Office Action Summary

10/733,124

BODET ET AL.

DETAILED ACTION

FIGURE A

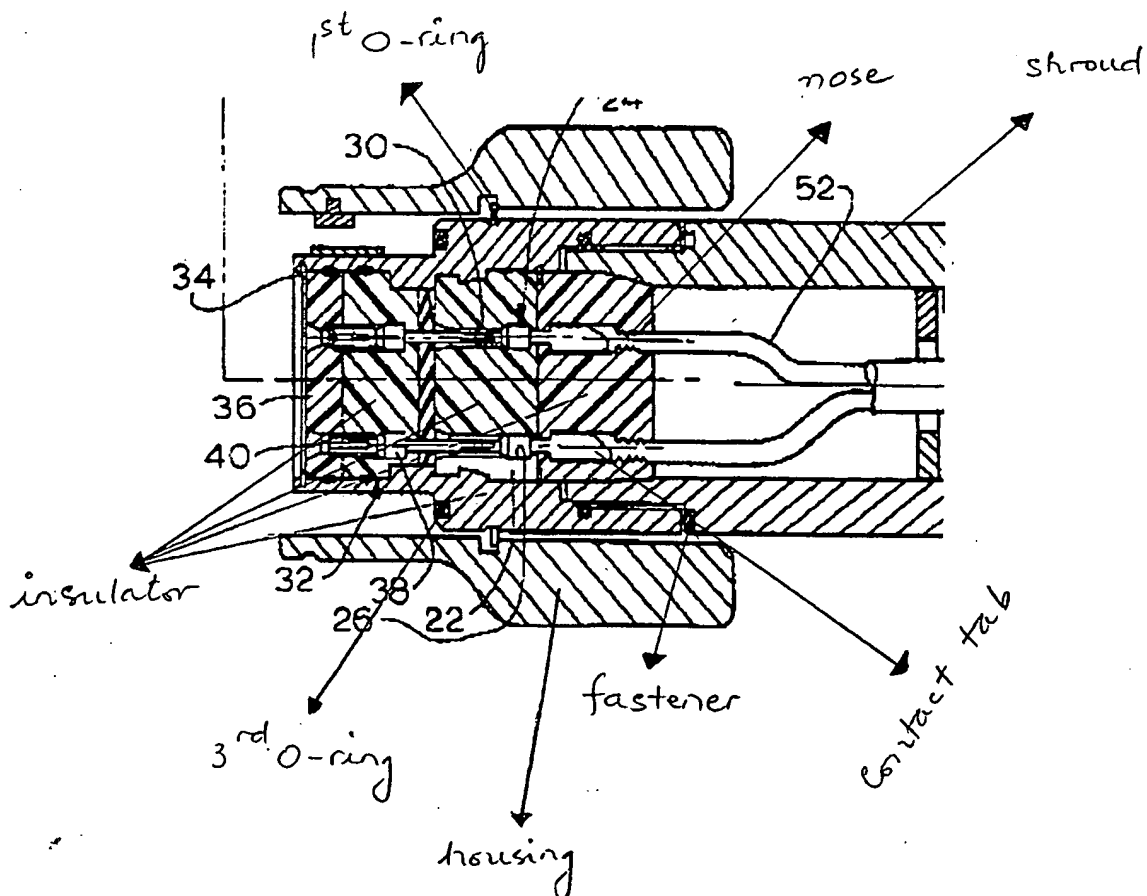
Regarding claim 4, Gerow, figure 2 shows a pressure-tight contact device for enabling an electrical connection to an electrical device housed in a pressure-tight housing, the contact device comprising an insulator (a FIGURE A below) extending through said housing (the FIGURE A below), at least one contact pin (38) extending through the insulator, a first O-ring seal (the FIGURE A below) for sealing the insulator relative to the housing, a connector shell (20) of insulating material positioned on the insulator and affixed to the insulator, the connector shell including a shroud (the FIGURE A below) and a terminal socket (not labeled) for receiving a connecting cable (50), at least one contact tab (30, 24 and the FIGURE A below) mounted in the connector shell, the at least one contact pin elastically and electrically connected to the at least one contact tab, a third O-ring seal (the FIGURE A below) for sealing the connector shell relative to the insulator, and at least one fastener (the FIGURE A below)

for affixing the connector shell to the insulator, the at least one contact tab and the shroud forming the terminal socket for mating with a connector member of the connecting cable.

Gerow discloses the claimed invention as described above except for a second O-ring seal for sealing the at least one contact pin relative to the insulator.

Regarding claim 5, Gerow shows the contact pin including at least one tip arranged and constructed to engage at least one opening (a front end of 30) defined in the contact tab.

Regarding claim 6, the at least one contact tab including at least one contact face (a front end of the opening) defined by the at least one opening, the at least one contact face bearing against the at least one contact pin to provide an electrical connection between the contact pin and the contact tab.

Regarding claim 8, Gerow shows nose member (the FIGURE A below) for positioning the contact tab in the connector shell (since 24 is a crimp terminal).
